RE: 3260 North Ohio Street

3260 North Ohio Street

RE: 3260 N Ohio Street Subdivision; Resubdivision Lot A Part Property of Kenton

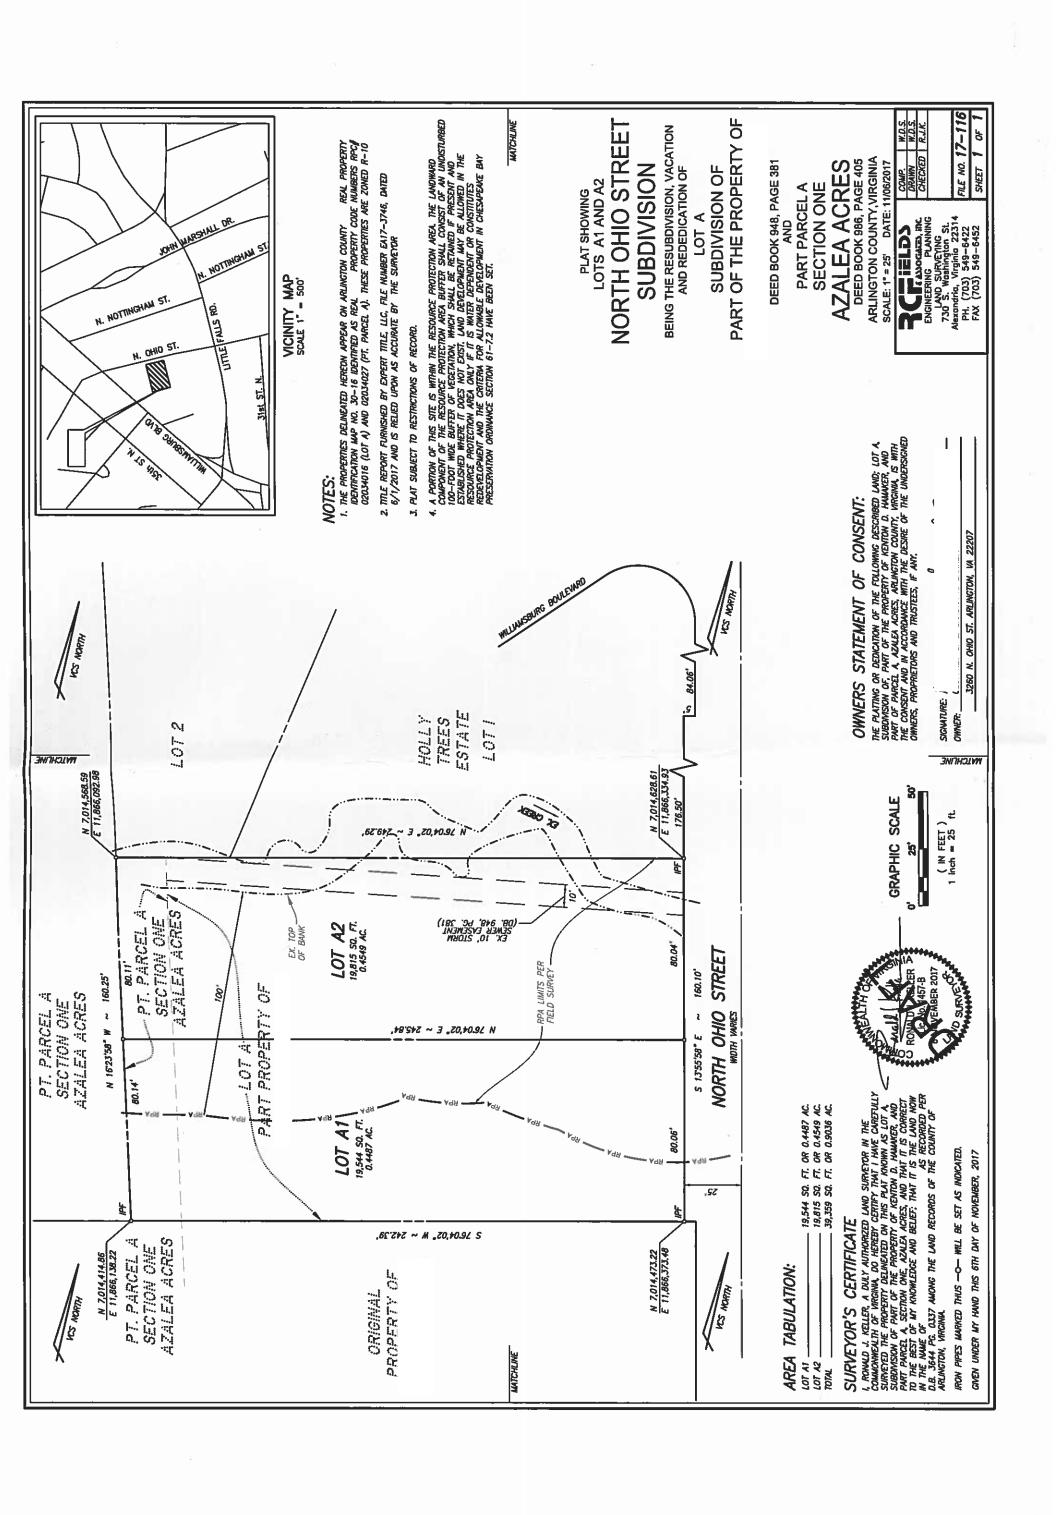
The attached "Final plat comments" show changes that must be made to the final plat itself. The proposed subdivision name of "North Ohio Street Subdivision" is acceptable; if you want to use "Ohio Street Subdivision" instead, that would also be acceptable.

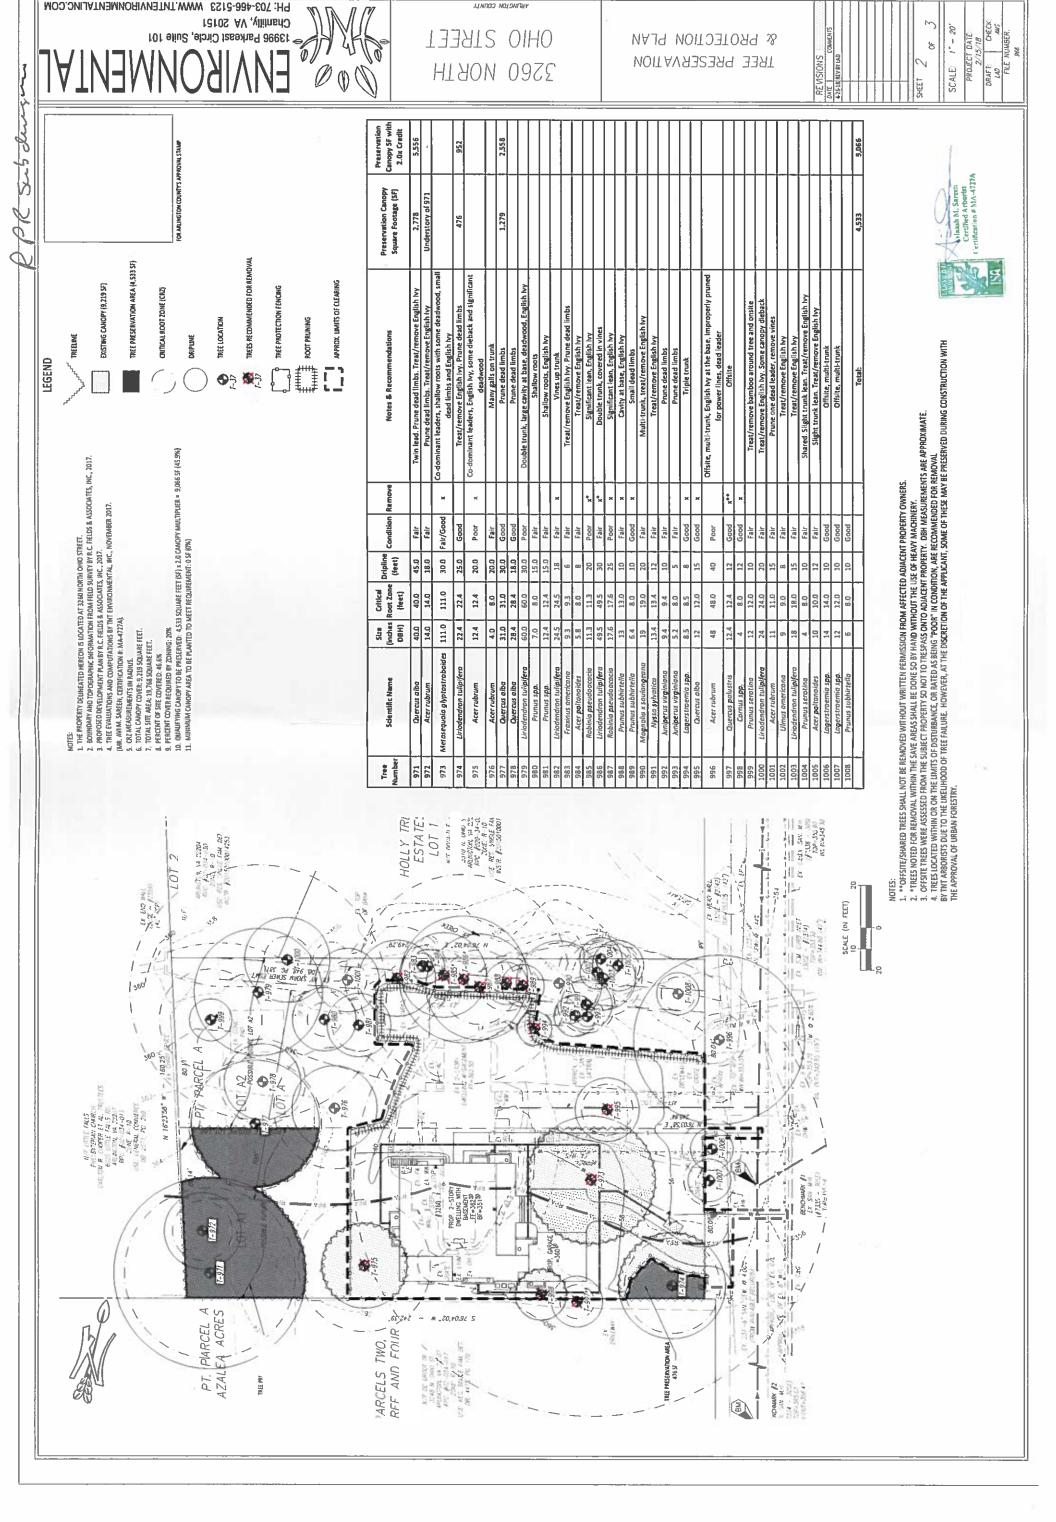
Preliminary plat approval comments #19 and 20 are still outstanding. Zoning must approve the subdivision prior to final plat approval.
